Our Ref: R/2008/16/i
File No: 2022/403674
Your Ref: MP 06_0162 MOD 9

Advice on Modification 9 - Barangaroo Concept Plan (MP 06_0162 MOD 9) - Central Barangaroo

Figure 2: Section showing the slope in topography from Observatory Hill down to the harbour (red dash added by the City to emphasise the slope of the landform)

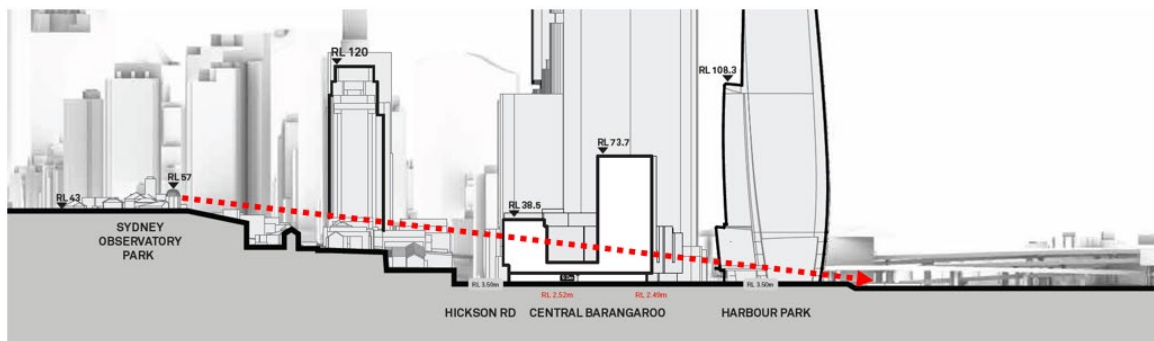
The modification will have adverse impacts on the interpretation of the surrounding landform, which has a clear change in topography from Observatory Hill down to the harbour (see Figure 2 below). The location of the proposed 74m high residential tower is particularly at odds with the surrounding landform as it is located at the low point of the cliff wall.

Figure 4: Proposed cantilevers over the public domain

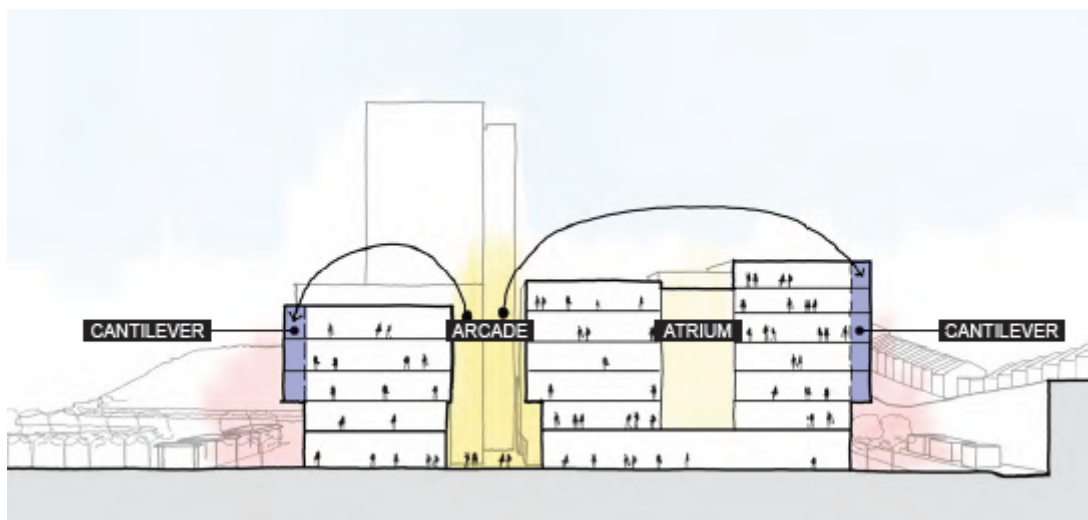
The planning envelope is proposed to be amended to include a 3m cantilever over the public domain on Hickson Road, Street D, Barangaroo Avenue and Barton Street (see Figure 4 below). The overhang will impact street tree viability, encroach on sky views, exacerbate visual bulk and blur private/public ownership and is not supported.

Particular concern is raised regarding impacts to Hickson Road, as the increased building heights and cantilevered design adjacent to the cliff face will create a 'canyon' effect and adversely impact the amenity of this road.
